Planning Commission Meeting Agenda,

209 PLAYHOUSE STREET VARIANCE APPLICATION

To: Planning Commission
From: Cindy Nash, AICP, EDFP
Date: August 31, 2023
Subject: Variance – 209 Playhouse

**CITY OF COLOGNE
PLANNING COMMISSION
RESOLUTION NO. 23-01
RESOLUTION DENYING VARIANCE FOR 209 PLAYHOUSE STREET EAST**

PLAN - main level addition + remodel

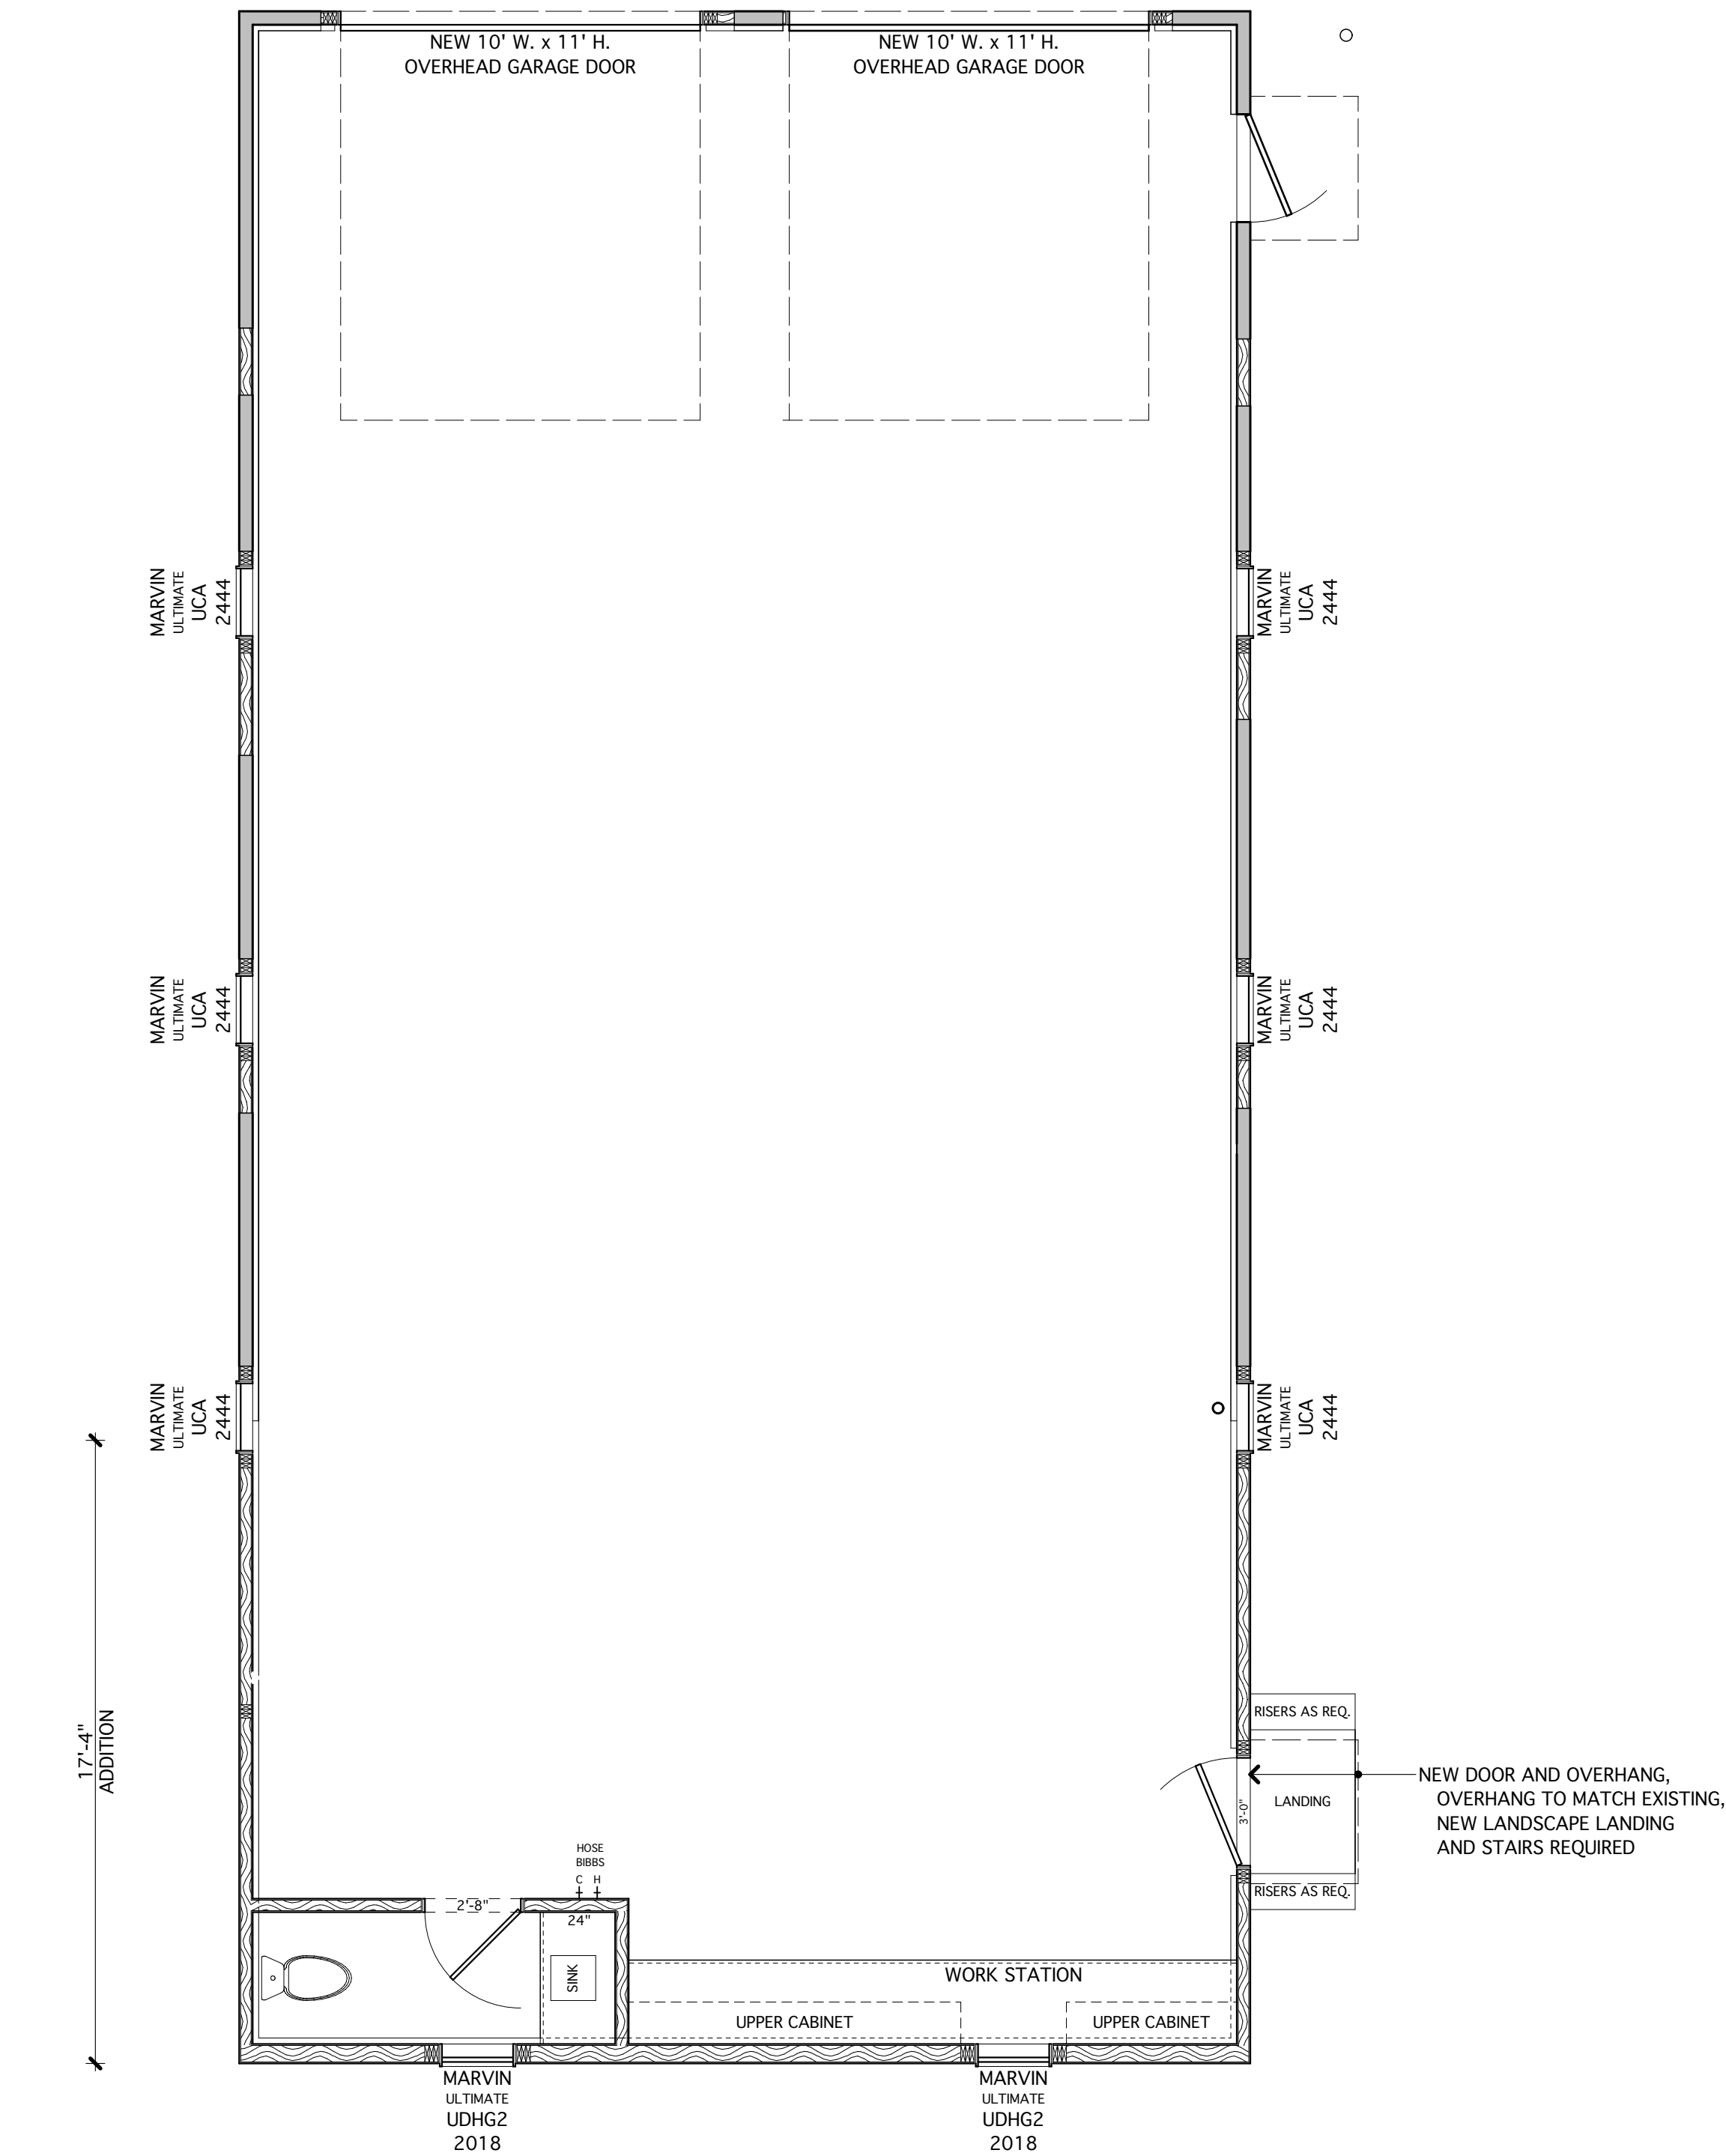
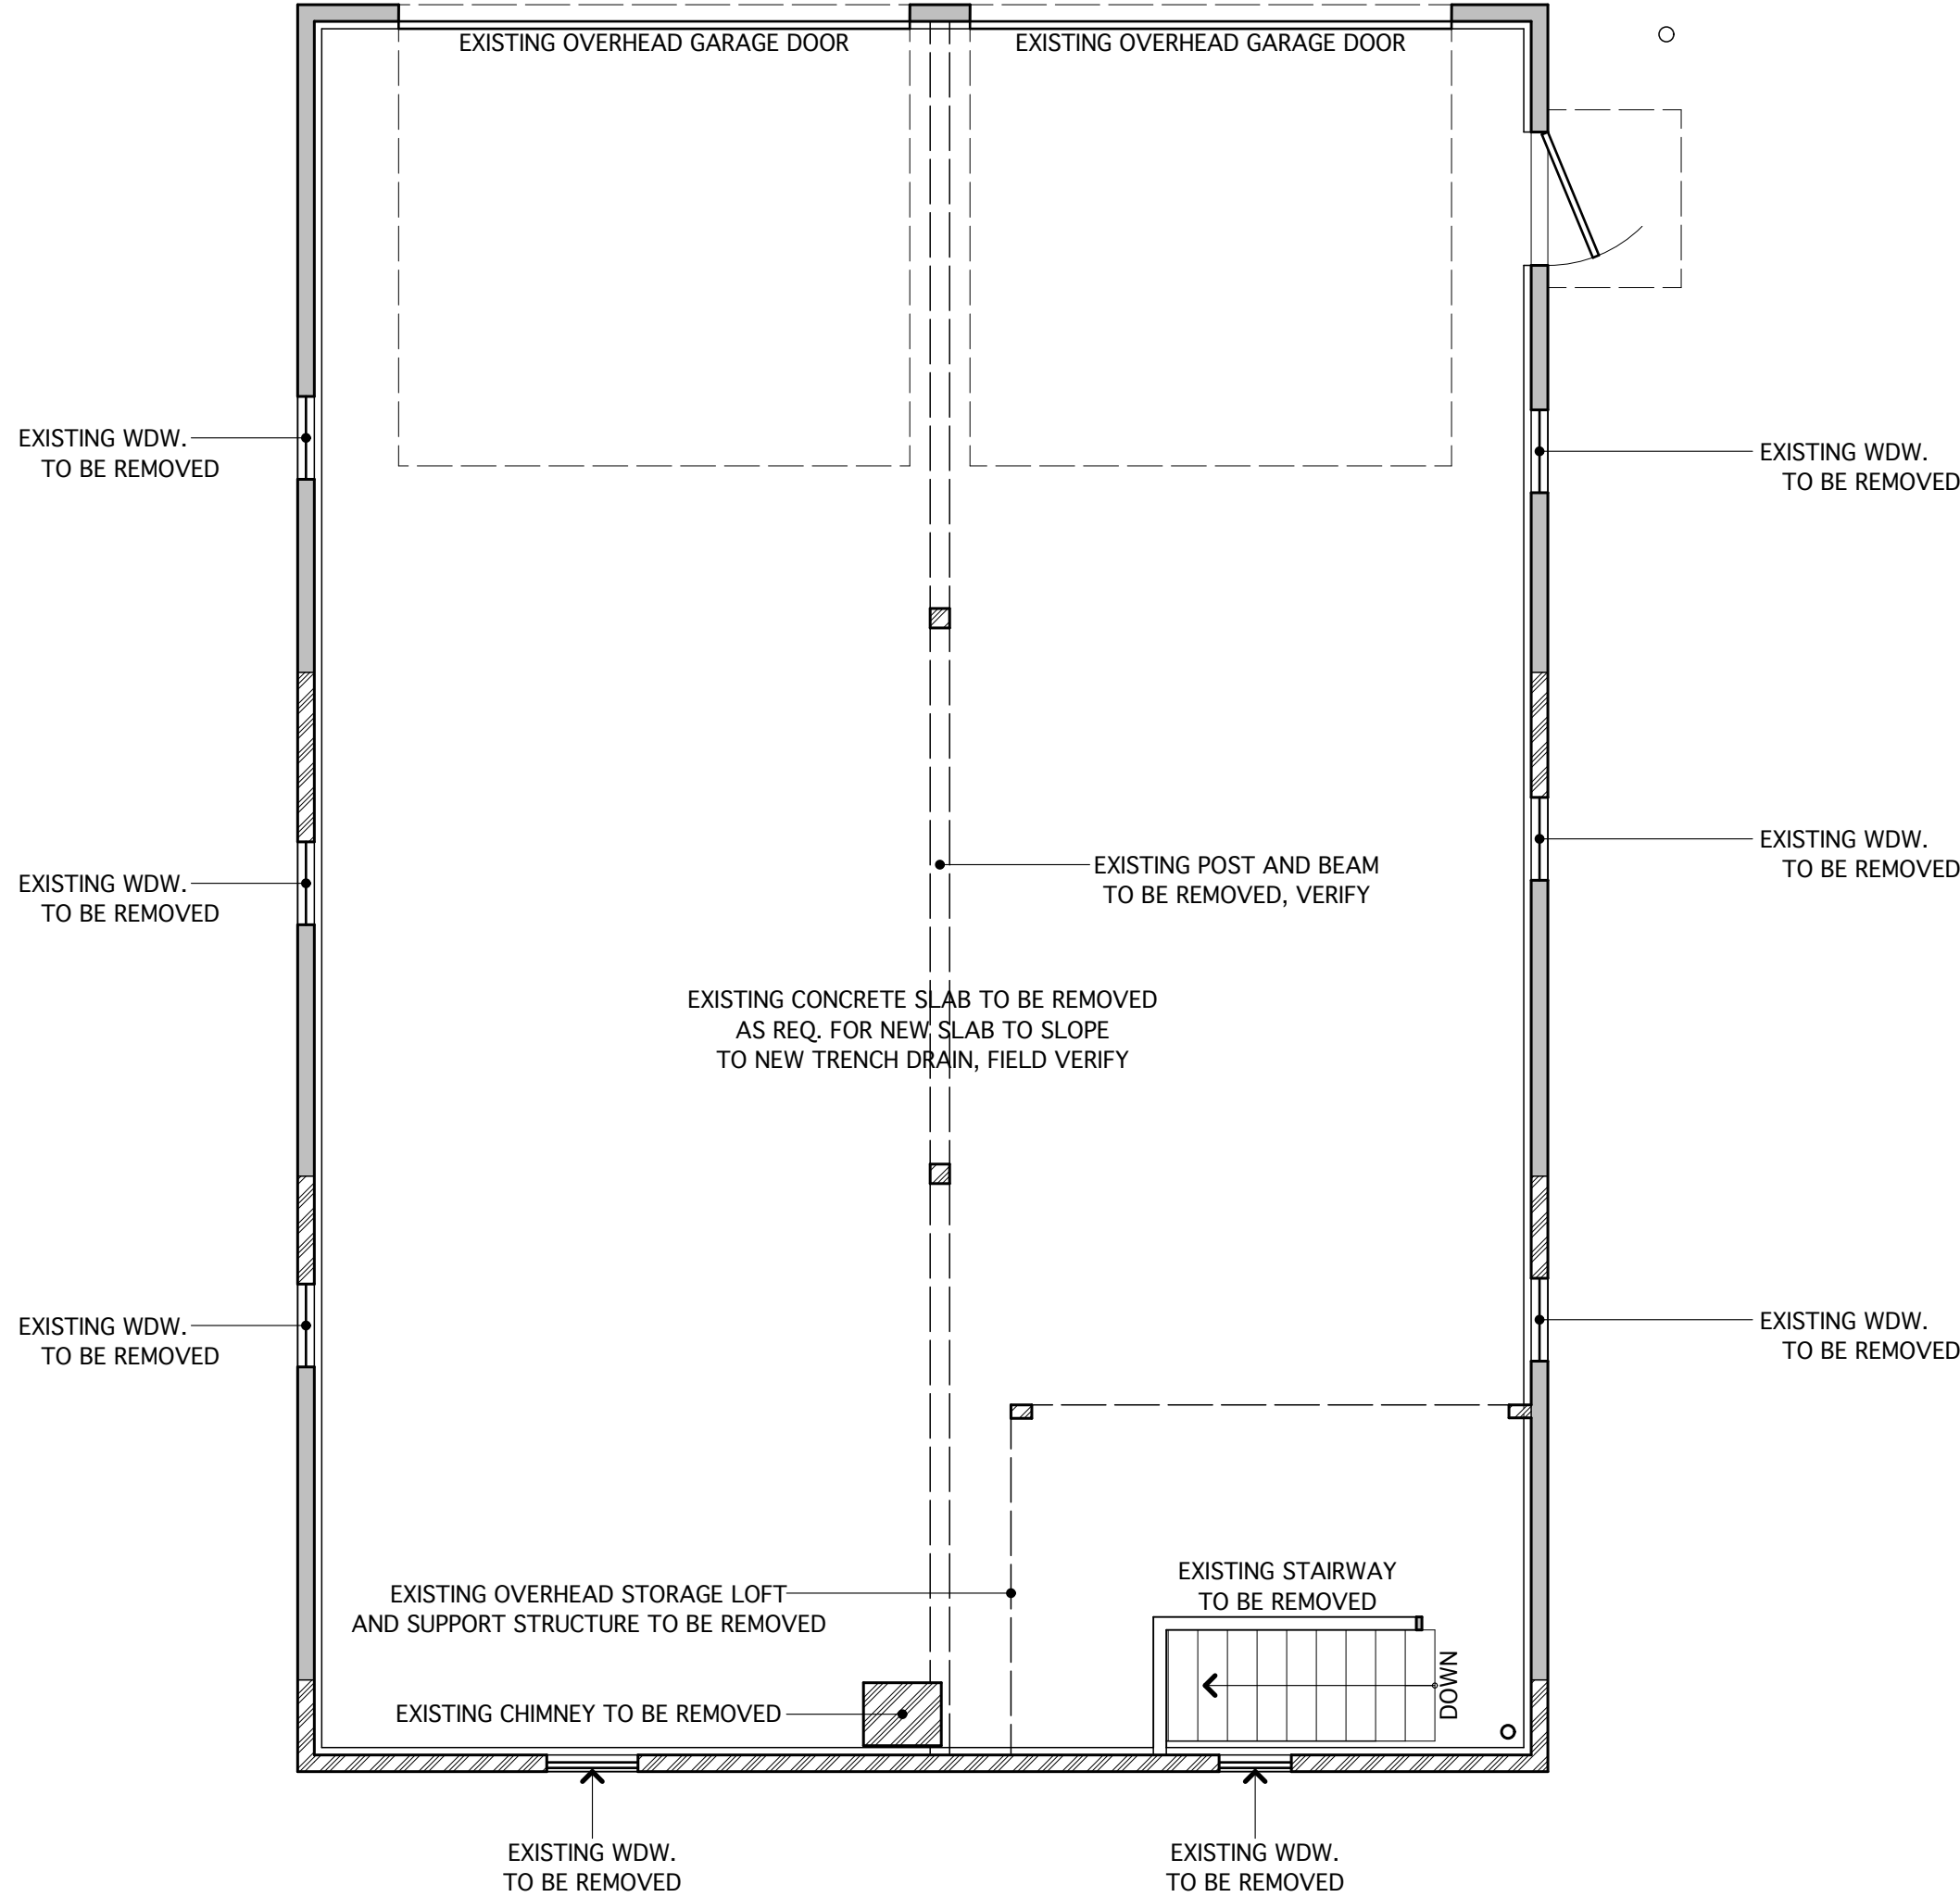
Staff Note: The construction proposed consists of structural repairs including but not limited to new roof and trusses, and removal of existing post foundations. This section allows for normal maintenance but not structural repairs. Minnesota Statute 462.357 Sub. 1e(a) may provide the applicant with additional ability to make structural repairs to the existing structure, but specifically excludes the expansion of a non-conforming use.

Furthermore, the initial application described the building as a “storage building”. The revised plans do not vary significantly from the original plan in overall design concept and still appears to be designed as a storage building. In the revised application received in August 2023, the applicant notes a number of activities that occur within the building, which are primarily related to storage use purposes. Minnesota law does not permit the City to grant a variance to allow a use which is not permitted or to expand a non-conforming use, and the expansion of the building for storage would amount to a use variance.
